**BIDDING AND CONTRACT DOCUMENTS FOR
CABARRUS COUNTY, NORTH CAROLINA
CONSTRUCTION AND DEMOLITION DEBRIS LANDFILL
PHASE 1L EXPANSION PROJECT**

CDM PROJECT NO. 1278-77070

ADDENDUM NO. 3

Date Issued: October 15, 2010

TRUCK LOAD OUT PIPING AT CONTAINMENT WALL

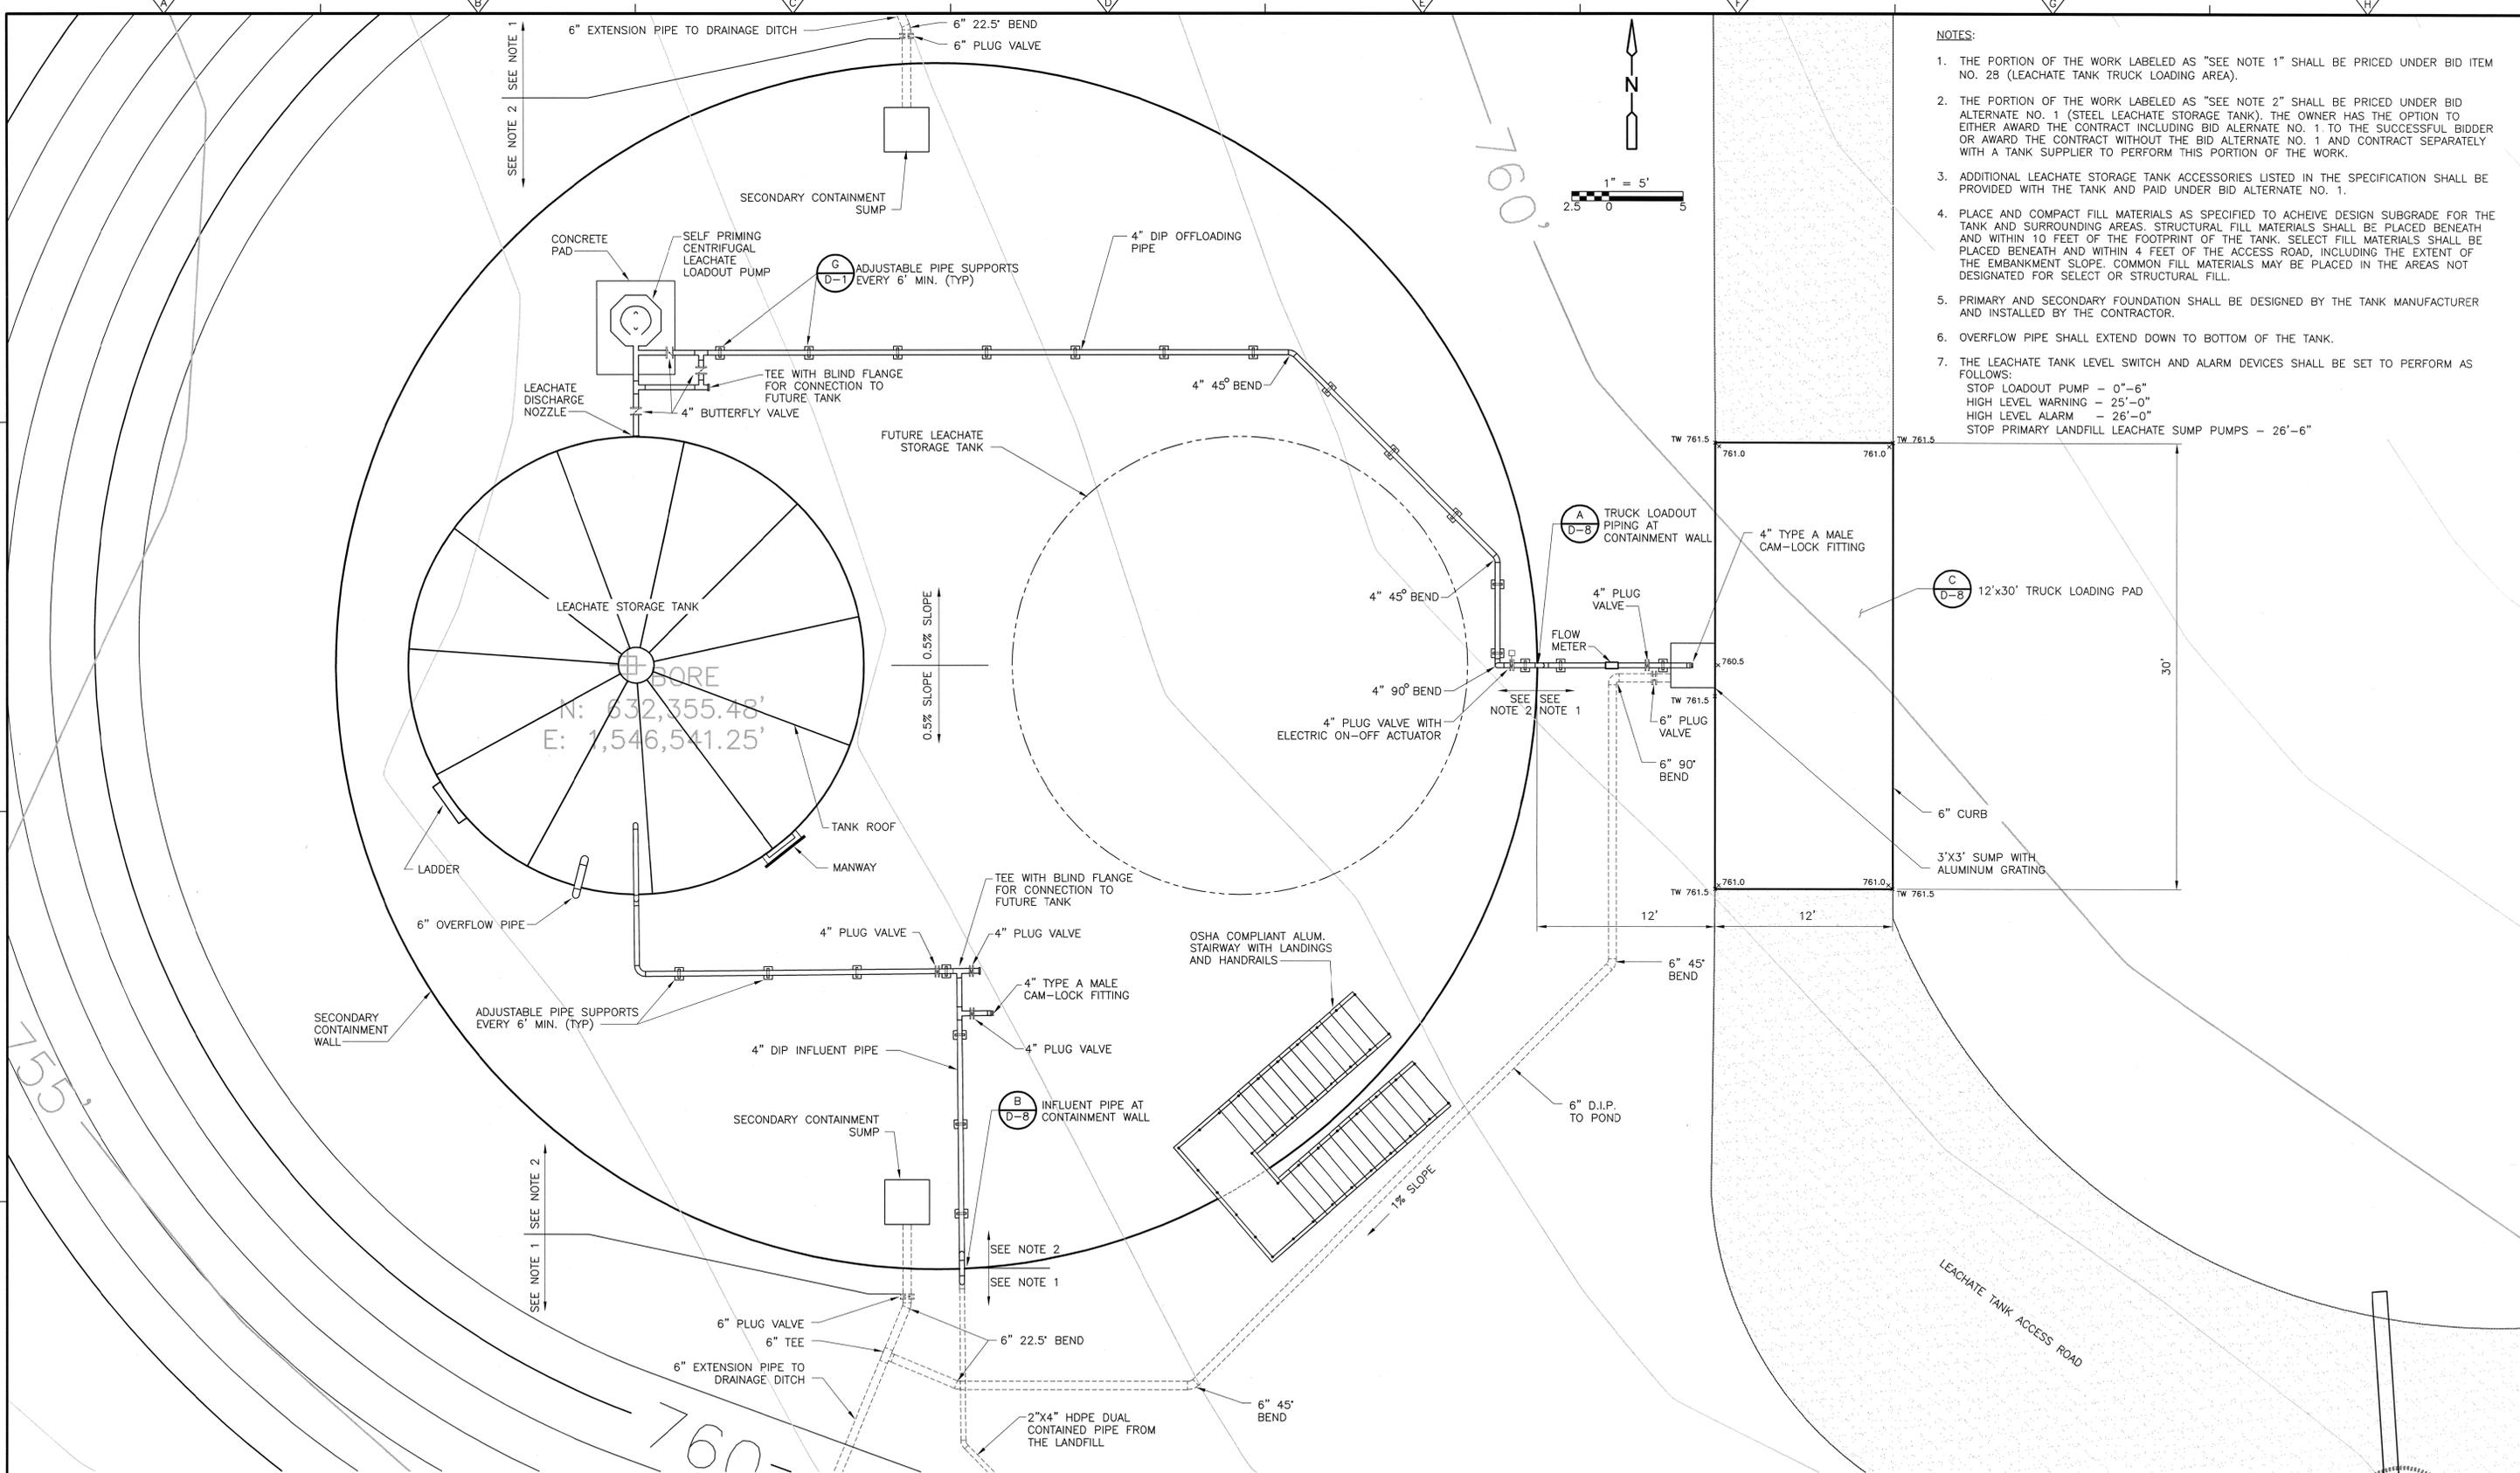
1. Detail A – Provided two 90 degree bends to lower the 4-inch pipe and the valve inside the containment wall as shown Figure 1.
2. Detail A – Added an air release valve as shown on Figure No. 1
3. Detail B – Added an air release valve as shown on Figure No. 2
4. Detail B – Added a 2"x4" HDPE reducer as shown on Figure No. 2

AIR RELEASE VALVE
 MODEL ARV100EPT-PV
 BY PLASTOMATIC, INC. OR EQUAL

CONTRACTOR TO CONNECT 4"
 HDPE TO 4" SS PIPE FLANGE,
 CONTRACTOR TO COORDINATE
 WITH TANK SUPPLIER
